PRODUCT CHANGE NOTIFICATION (PCN)

AMJE0909-0500-BUB-24
MODULAR CABLE

CHANGE NOTIFICATION: PCN 20220509_AMJE0909-0500-BUB-24

DESCRIPTION OF CHANGES:
CHANGE OF DATA SHEET
CHANGE OF DATA SHEET
New Draw.-No. ASS_7945_CArev02

AMJE0909-0500-BUB-24 OLD VERSION

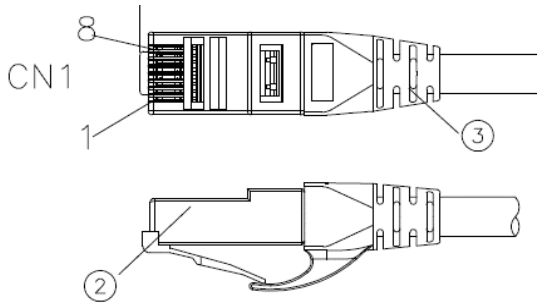
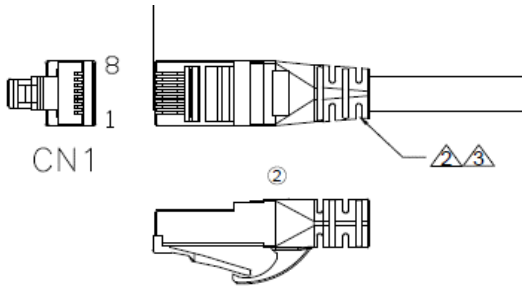
③	Molding	PVC 45P Color: see order code	NA	KG
②	CONNECTOR	RJ45 8P8C two fork Short type 3u" gold plated	2	PCS
①	CABLE	CAT6 UTP (24AWG*1PR)*4+PVC OD=5.8±0.3MM Color: see order code	NA	MM
NO:	NAME	DESCRIPTION	Q'TY	UNIT

3	Molding	PVC 65P Color: see order code ②	NA	KG
2	CONNECTOR	RJ45 8P8C PLUG 3u" gold plated ②	2	PCS
1	CABLE	CAT6 U/UTP (24AWG*1PR)*4+Cross+PVC Jacket OD=5.8± 0.3MM Color: see order code ②	NA	MM
NO:	NAME	DESCRIPTION	Q'TY	UNIT

Drawing-No.
ASS 7945 CA

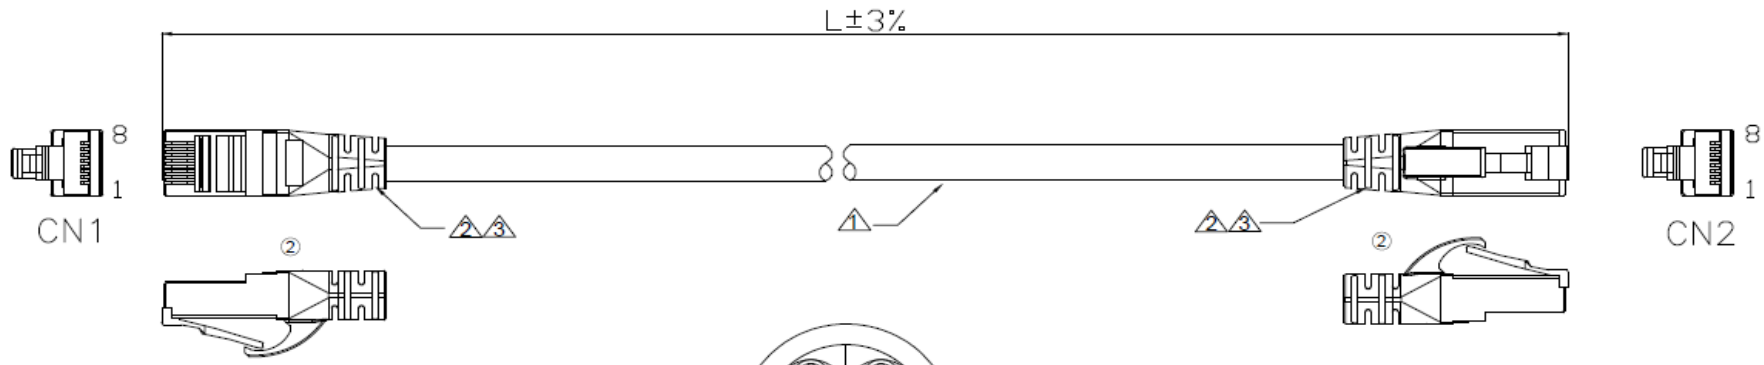
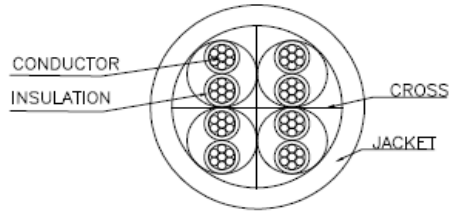
Id.	Modification	Date	Name
②	Change the plant	09.05.2022	Luca
①	Update the WSW order code	02.06.2017	Amy
⓪	Drawn	30.03.2017	Amy

NO:	NAME	DESCRIPTION	Q'TY	UNIT
3	Molding	PVC 65P Color: see order code ②	NA	KG
2	CONNECTOR	RJ45 8P8C PLUG 3u" gold plated ②	2	PCS
1	CABLE	CAT6 U/UTP (24AWG*1PR)*4+Cross+PVC Jacket OD=5.8± 0.3MM Color: see order code ②	NA	MM
